ASI-01

Project: DeIDOT Georgetown Administration Building

Project No: T202180102

1 ENLARGED TOILET ROOM FLOOR PLANS
 ASK-02 SCALE: 3/8" = 1'-0"

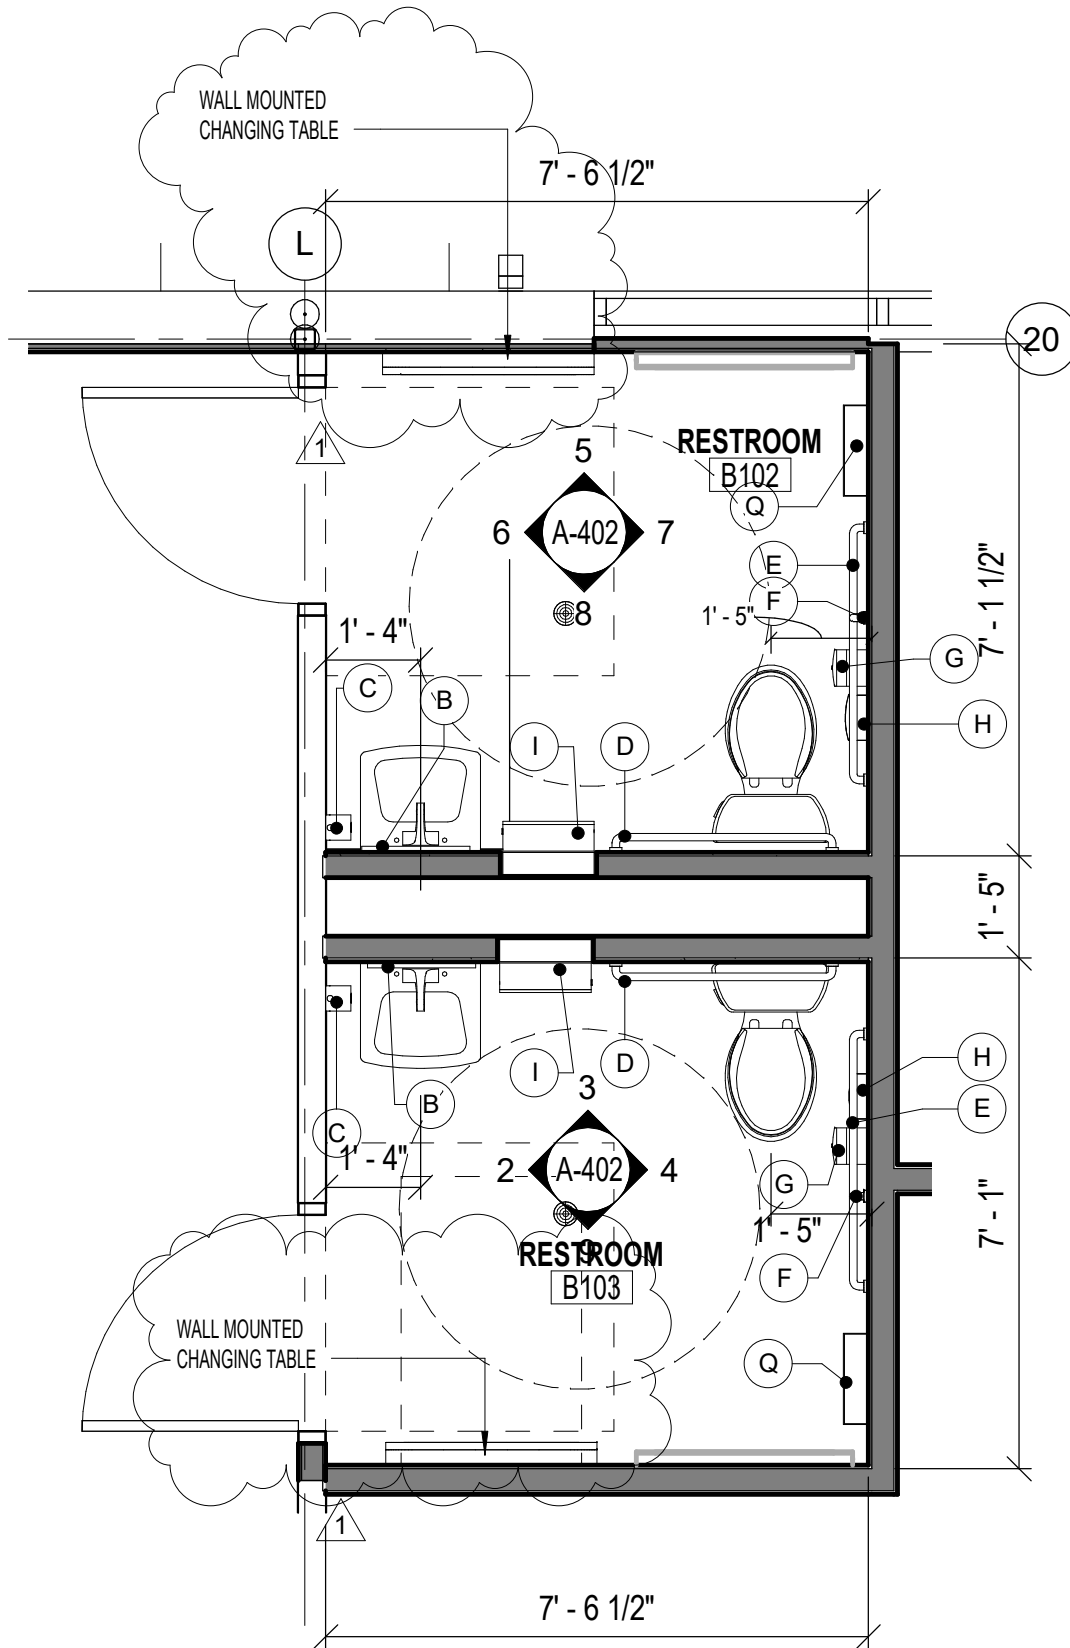
Purchase and install (2) diaper changing stations in single bathrooms at Conference Room. Provide pricing for product and installation. See sketch ASK-02 for location.

Changing Table Basis of Design: Bobrick KB200
